Evaluation of the report of Tokyo Electric Power Company regarding the leakage from the 4000-t square steel tank cluster at the Fukushima Daiichi Nuclear Power Station

28 April 2015

Nuclear Regulation Authority, Japan

Figure 4 Data on leakage outside the dike (extracted from the TEPCO report)

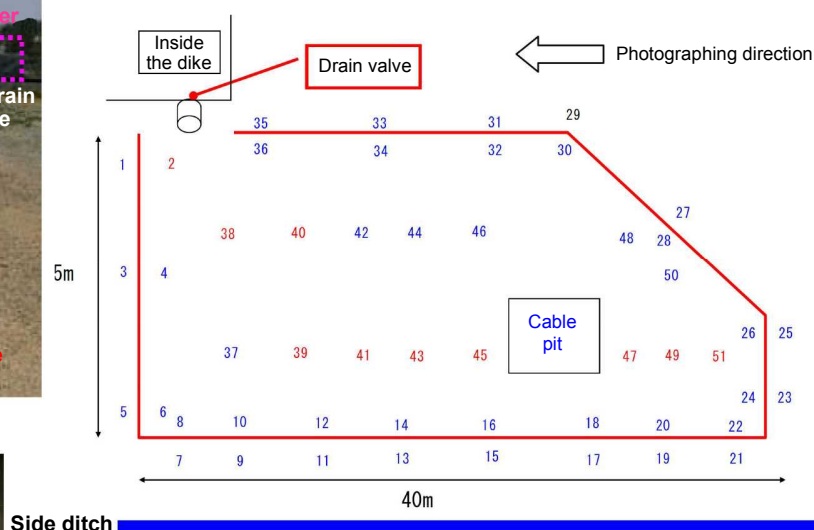
Despite the fact that the leaking water was dripping into a dike, the dike’s drain valve remained open. Tokyo Electric Power Company (hereinafter, referred to as “TEPCO”) measured the radiation dose (70 µm dose equivalent rate (β rays)) on the ground around the drain valve and outside the dike, finding a maximum radiation dose of 0.028 mSv/h within the area up to a distance of approximately 40 m from the drain valve. TEPCO therefore concluded that water in the tanks leaked outside the dike (refer to Figure 4).

- a. The drain valve, which remained open, allowed stored water that leaked into the dike to further leak outside the dike.
- b. No patrol was performed around the notch tank cluster, and thus the leakage from the portions around the bolts was not discovered.

- b. Countermeasure to ensure the dike drain valves are closed
 - All drain valves of dikes in the notch tank cluster shall remain "closed." Rules regarding this operation shall be stipulated in company manuals.

**Figure 5 Formation of an opening at a notch tank top panel
(extracted from the TEPCO report)**

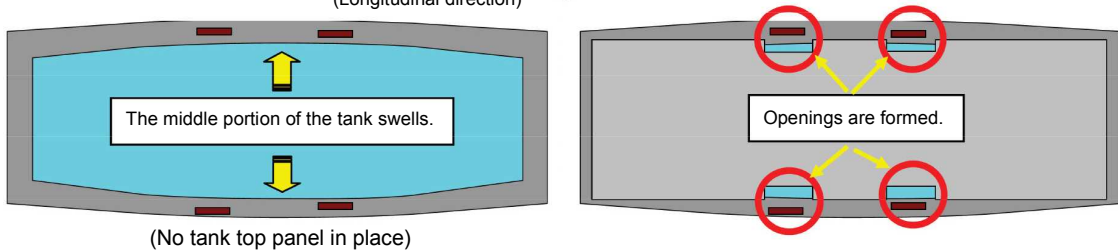
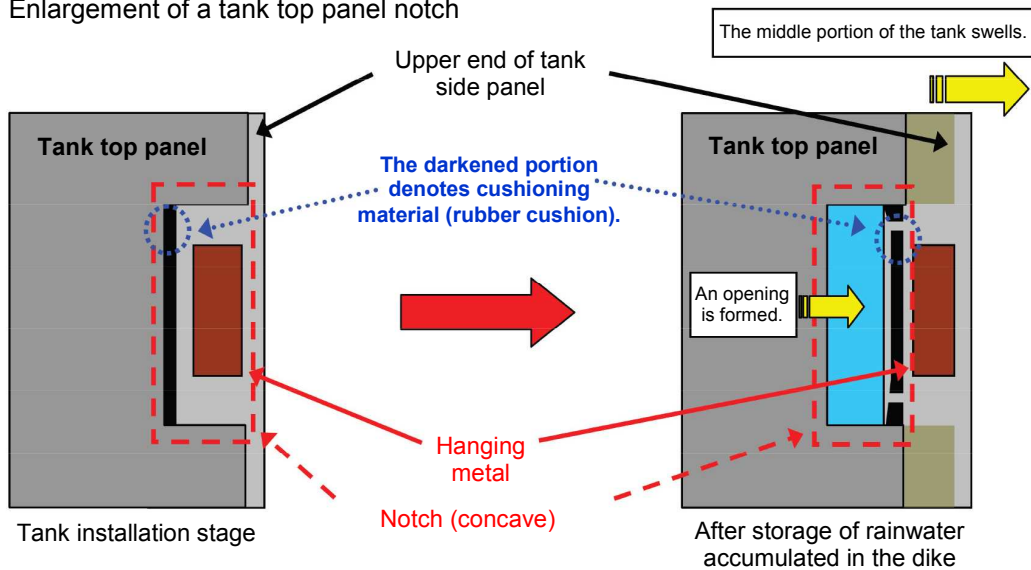
While storing water, the tanks swelled in the middle of the upper-end part of their side panels. This swelling caused gaps (openings) to develop between the tanks' top panels and hanging metal attached to the upper end of the tanks' top panels (refer to Figure 5).

Rainwater entered the tanks through these openings that had formed at the tanks' top panels, gradually leading to an increase in the water level of the 1000 t notch tank cluster. As a result, stored water leaked into the dike from the portions around the bolts, which had low cut-off performance.

The notch tank stores rainwater accumulated in the dike, and its middle portion thus swells outward. As a result, gaps (openings) are formed between the notches of the tank top panel and the hanging metal at the upper end of the tank side panels.

- Covers shall be installed over the notch tank cluster to prevent rainwater from entering the openings along tanks' top panels and to prevent rainwater accumulation from increasing in the dike for the notch tank cluster.

- Inspections shall be carried out on the notch tank cluster once a week to confirm that tanks' water levels do not exceed the reference upper limit (approximately 20 cm below the tanks' top panels).

Figure 6 Results of drainage-ditch and ocean monitoring (extracted from the Secretariat of the NRA's document for a meeting with TEPCO)

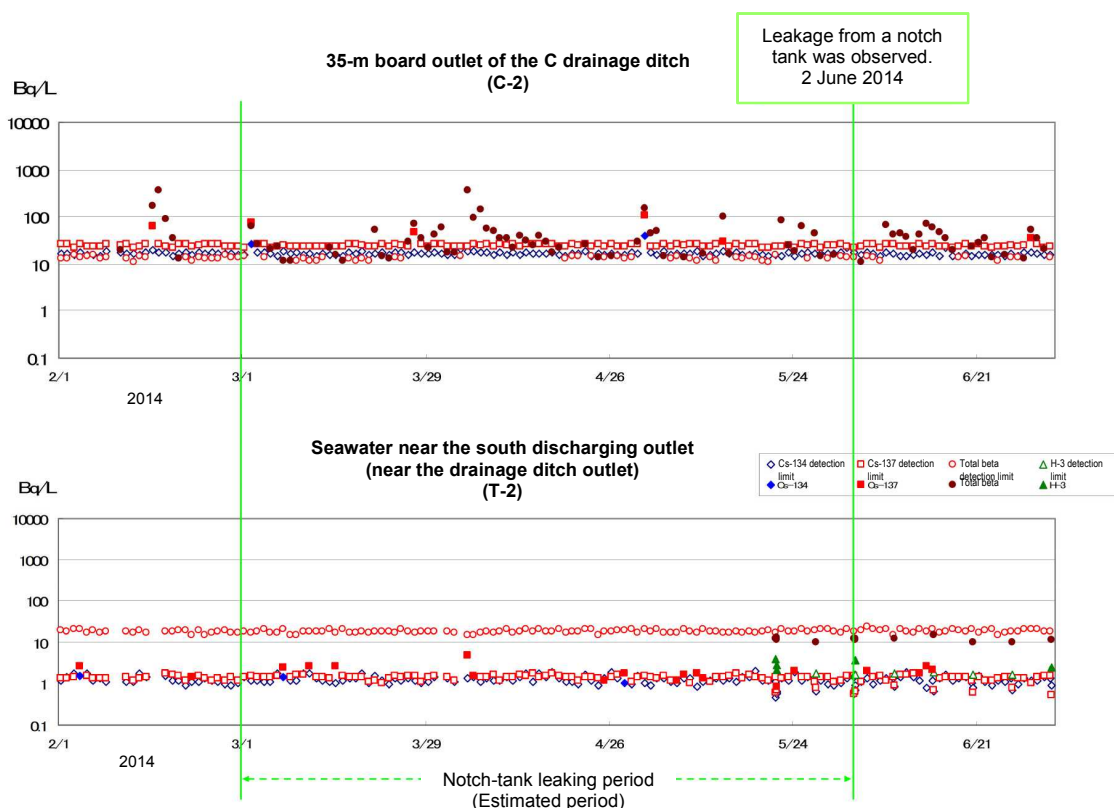
There is no obvious fluctuation in the results of monitoring before and after the leakage occurred in the vicinity of the 35 m board outlet (C-2) of the C drainage ditch and the vicinity of the south discharging outlet (T-2). The NRA therefore concludes that this event did not cause ocean contamination that raises any concerns about effects on health or the environment (refer to Figure 6).
